ADDENDUM NO. 1

Date of Addendum: 9/17/15

PROJECT NAME: Keegans Bayou WWTP Improvements

PROJECT NO: WBS No. R-000265-0101-4

INFLUENT PUMP STATION
KEEGANS BAYOU
WASTEWATER TREATMENT PLANT

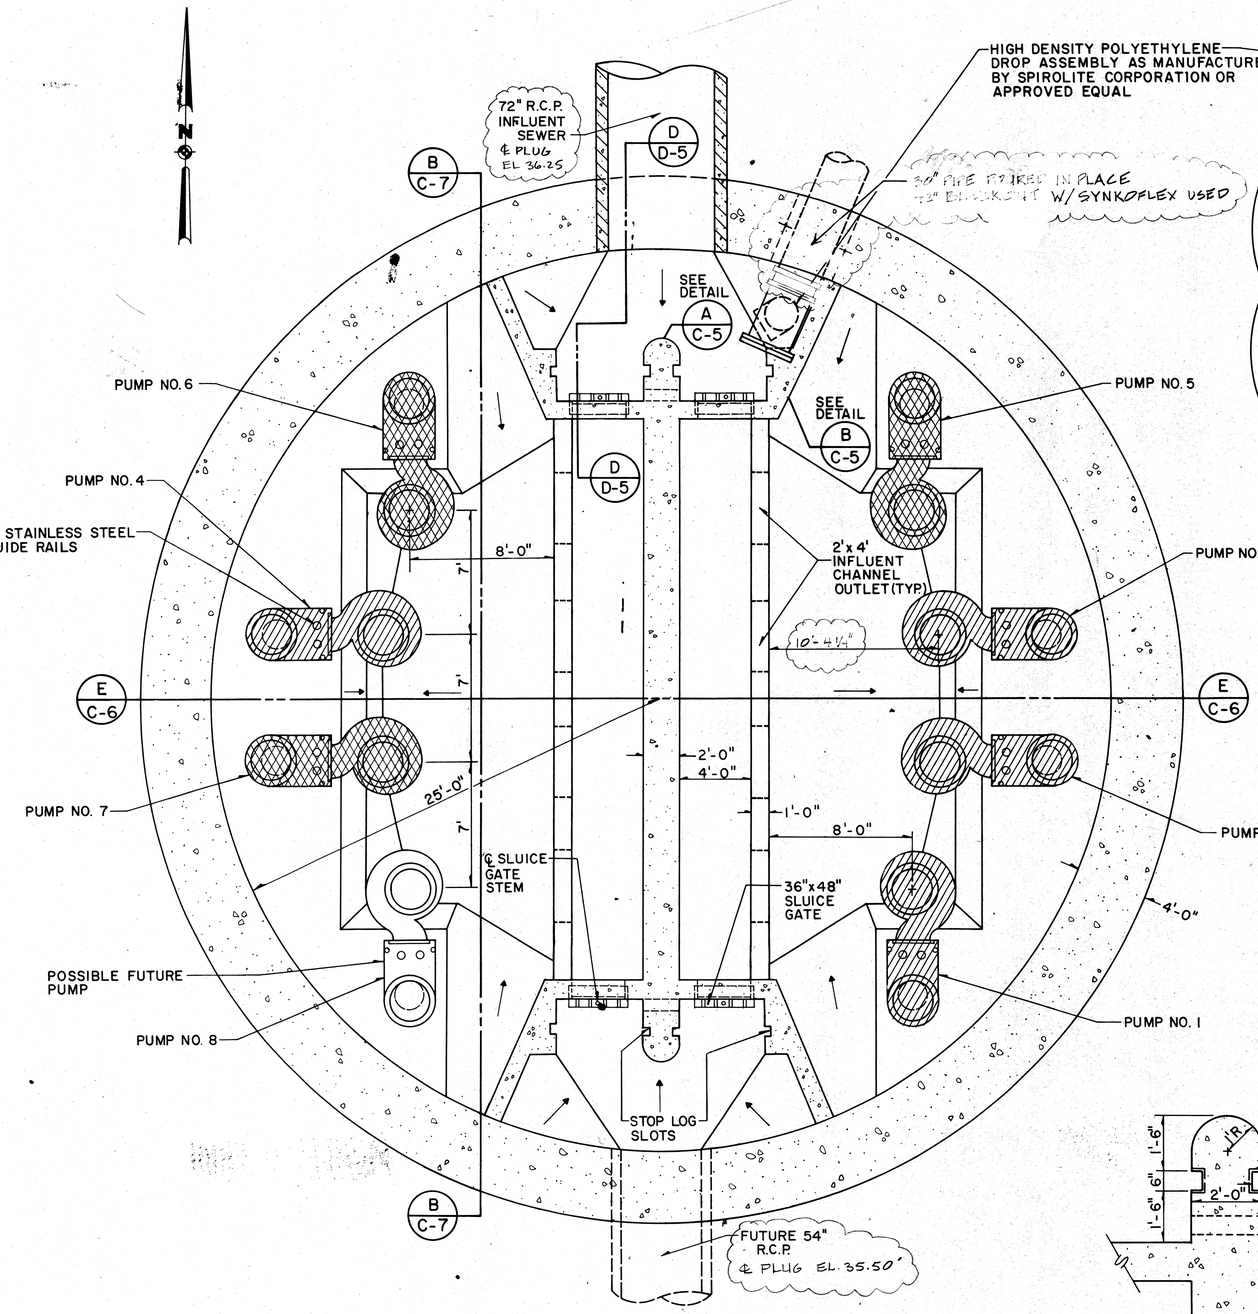
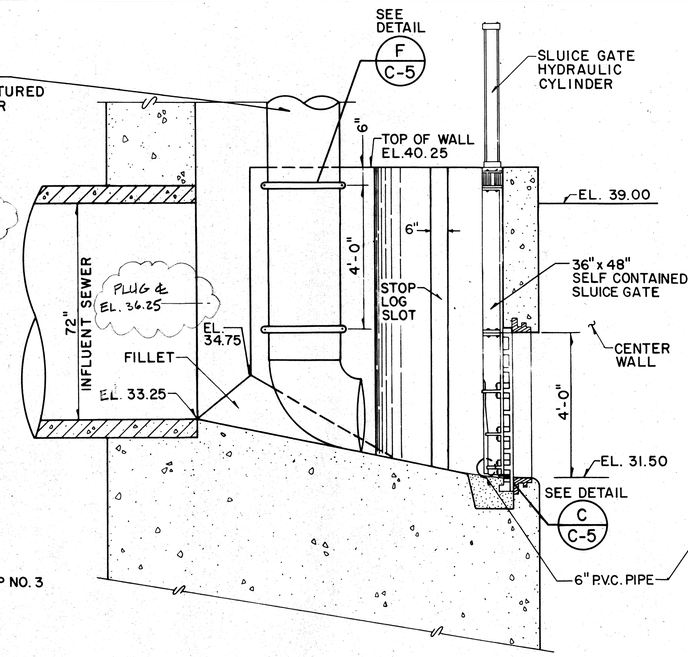
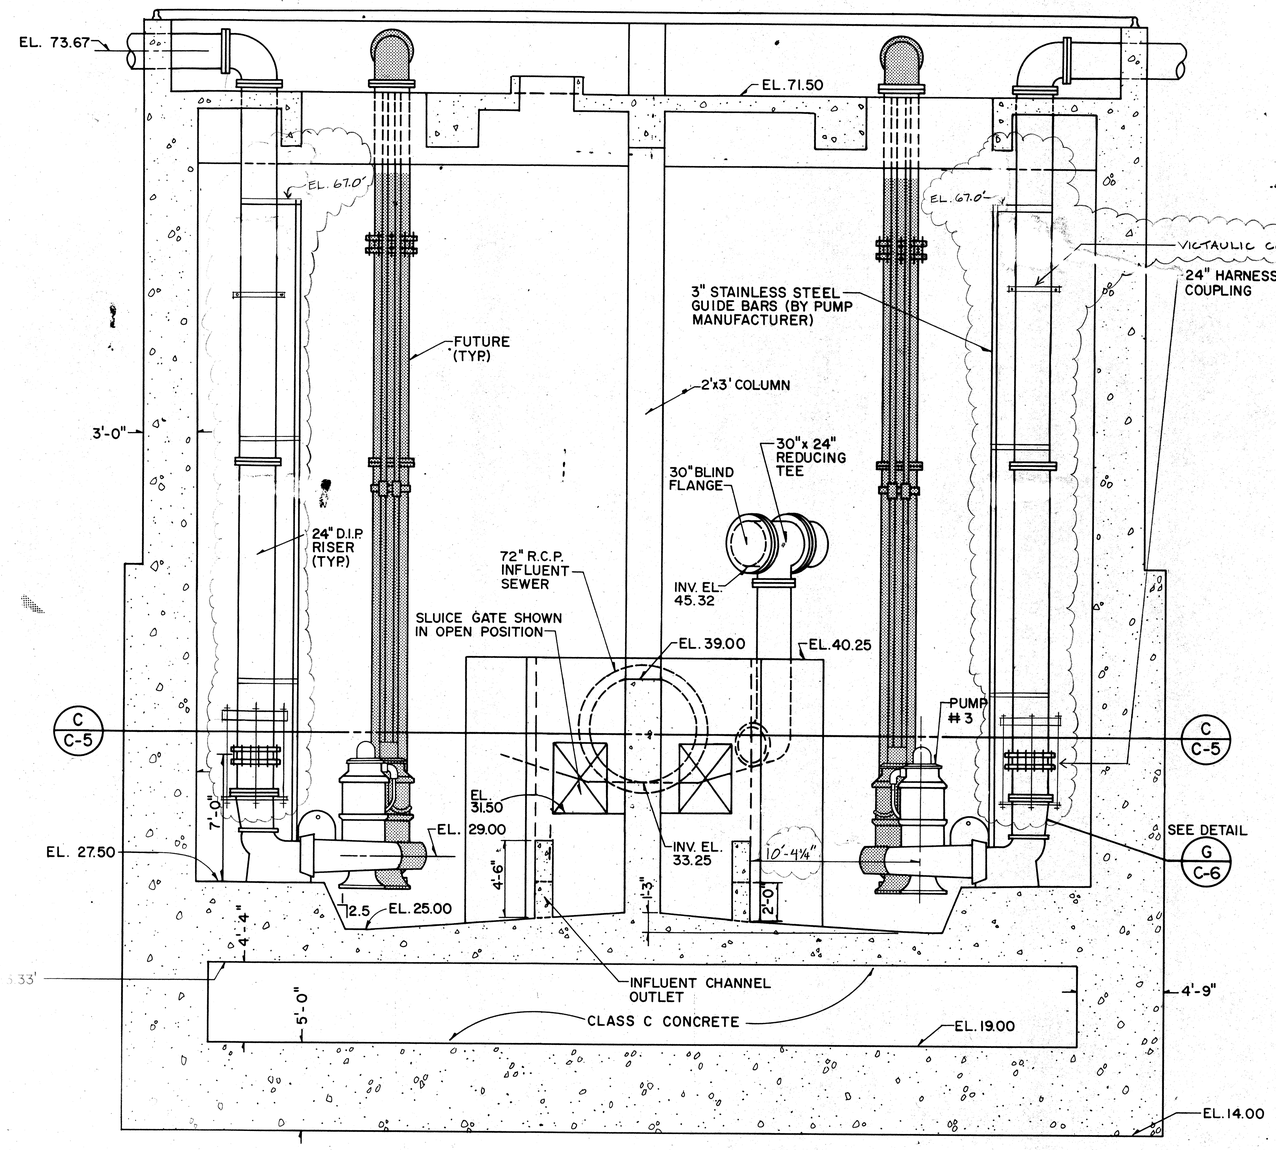
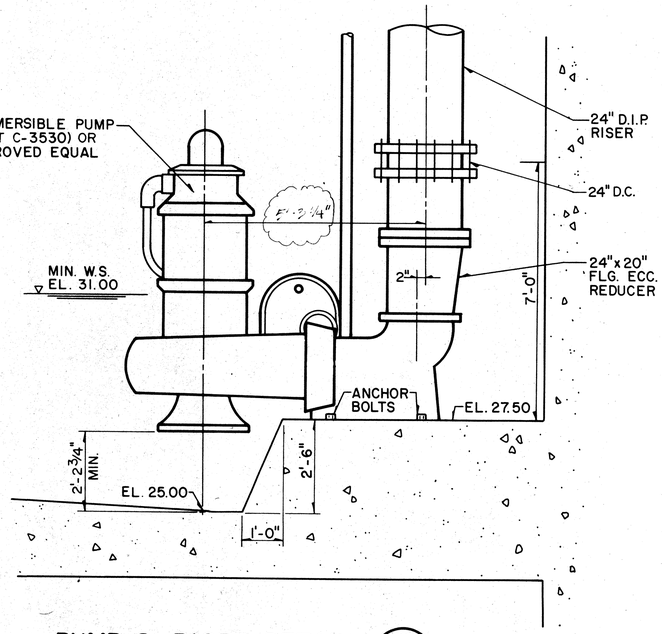
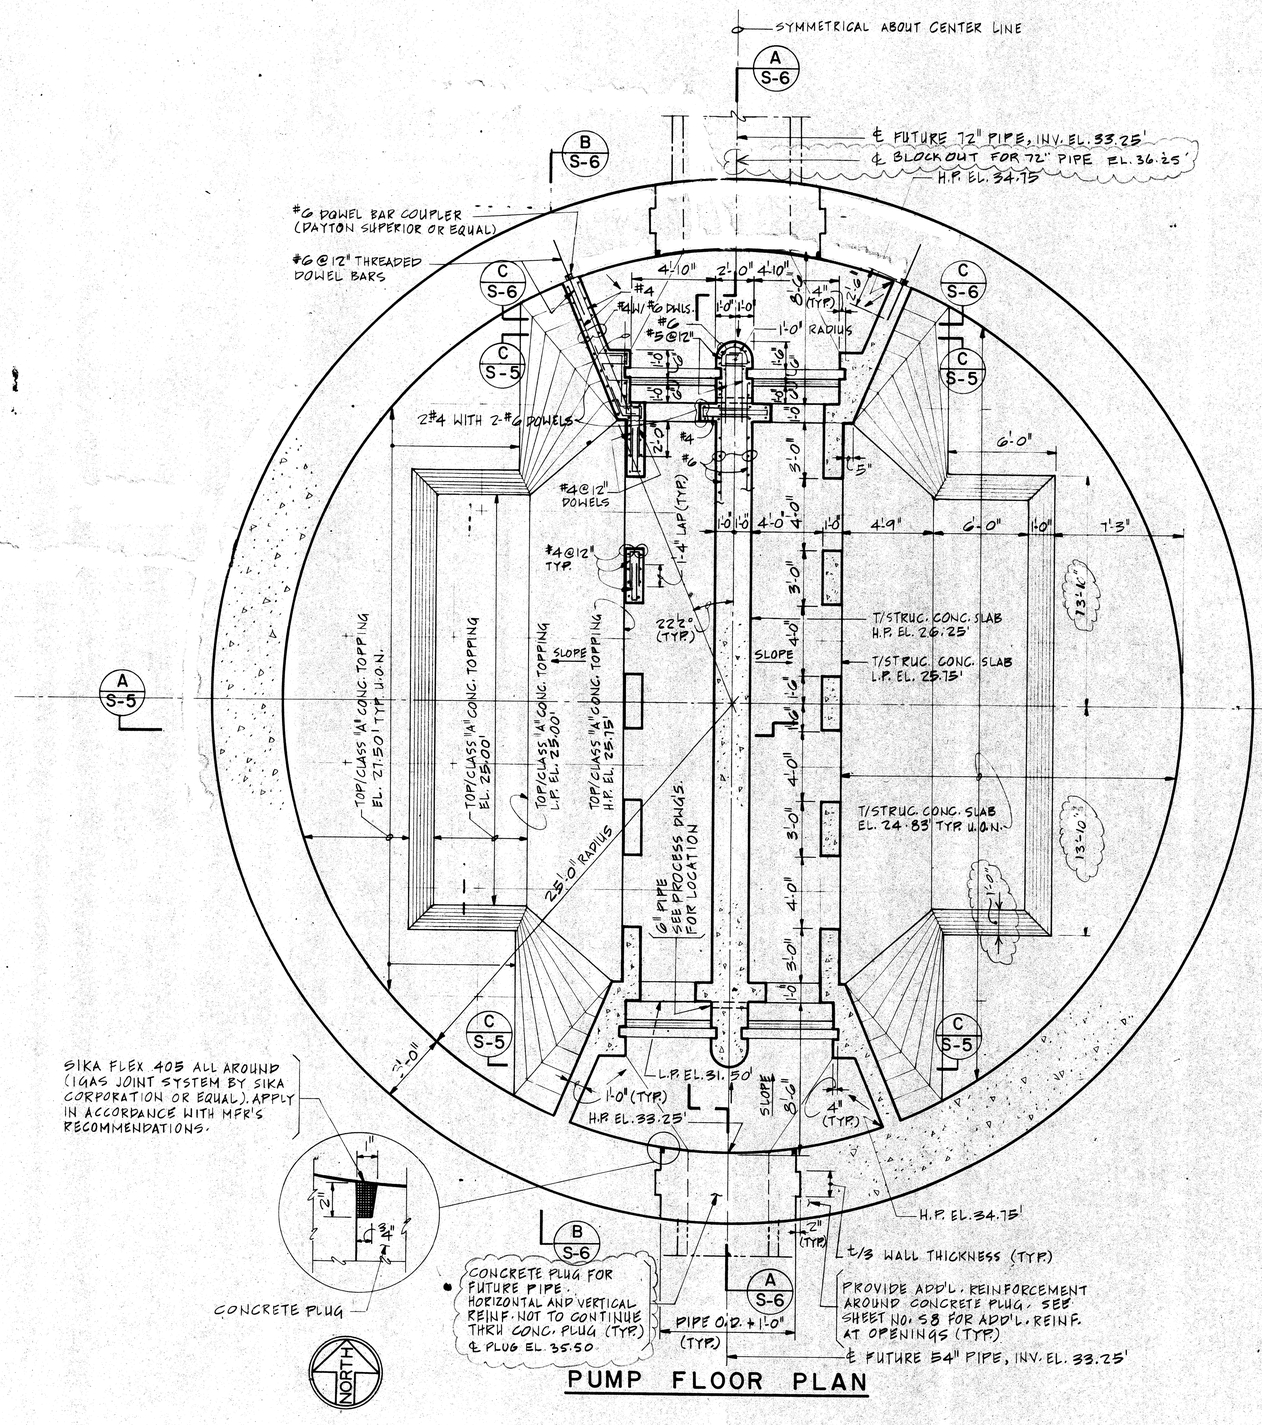
18. Question: Note 4: Contractor to install temporary cofferdam or stop logs as required to isolate the chambers (East and West of the lift station. The existing sluice gates in the wet well shall not be used.
Please provide sufficient detail of the wet well to construct the bypass.
Where are the existing sluice gates, none are shown?
Answer: See the attached plan and section for the lift station from as-built drawings.

44. Question: Please provide structural details for the influent lift station so we know how to design the stop logs. Answer: See the attached plan and section for the lift station from as-built drawings.

52. Question: Can we get as-builts of the existing lift station for stop log groove dimensions, etc.? Answer: See the attached plan and section for the lift station from as-built drawings.

provided so we know depth, closest manhole, manhole size, etc? Answer: The depth of the line is shown on the section of the lift station. The nearest manhole is in the middle of the street to the north of the lift station. See attached drawings from as-builts.

Job No. 81084-25	Sheet	
Date: MAR. 25-86	S-61	
Dwn. By: J. HILL	198	
Chkd. By: R. F.	of 284

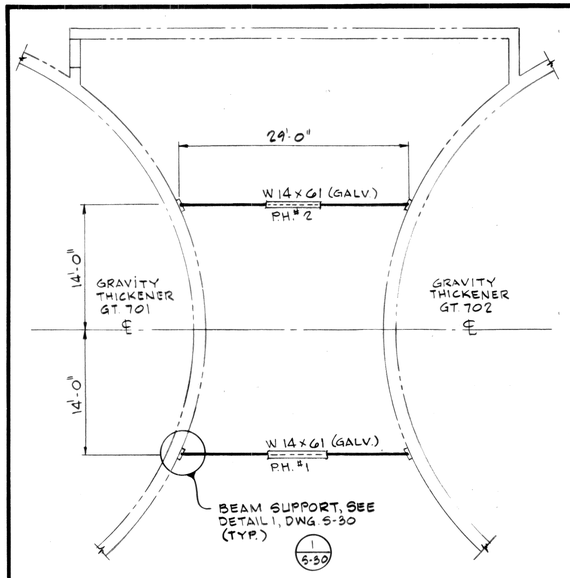
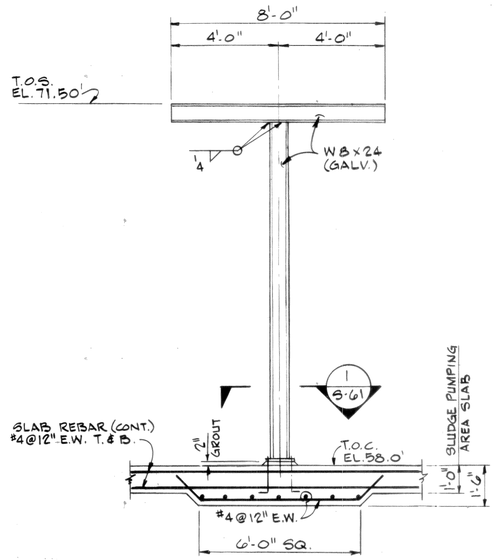
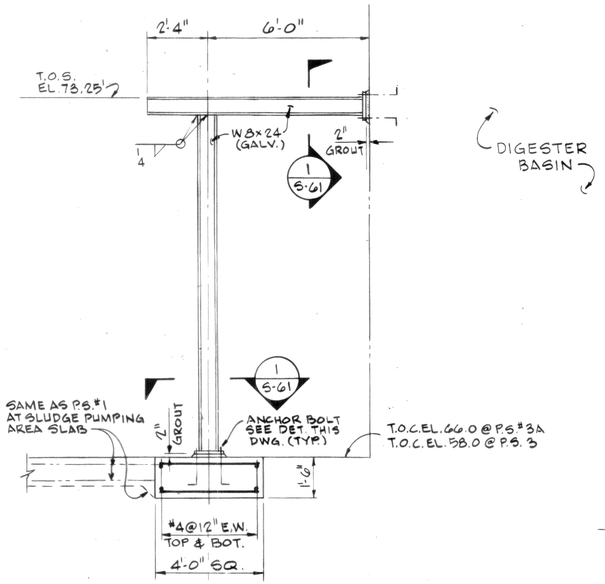
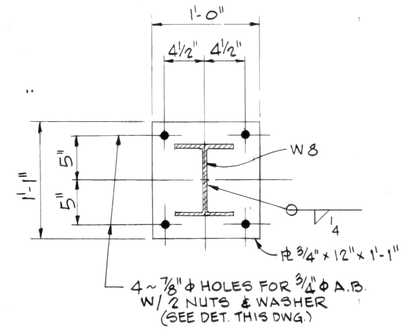
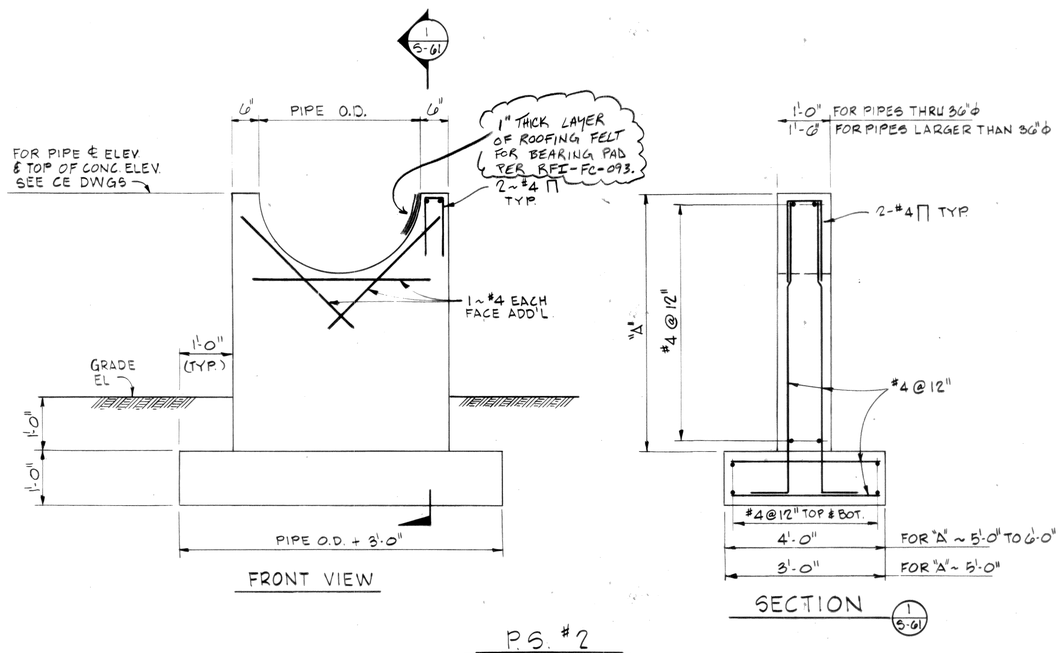
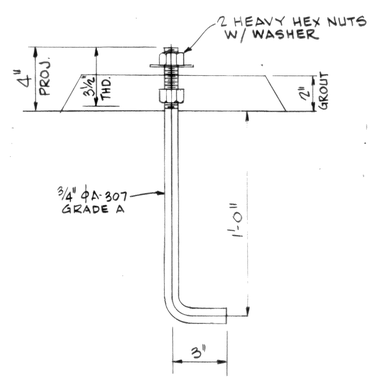
56. Question: Sheet 33: we route the new 24" sludge lines under the existing 54" clarifier feed lines. The 54" piping is aboveground on concrete supports. Please provide details/depth of the existing supports and what is required for replacement supports. Answer: Attached is the only “Pipe Supports” sheet from the original drawings, Sheet S-61.
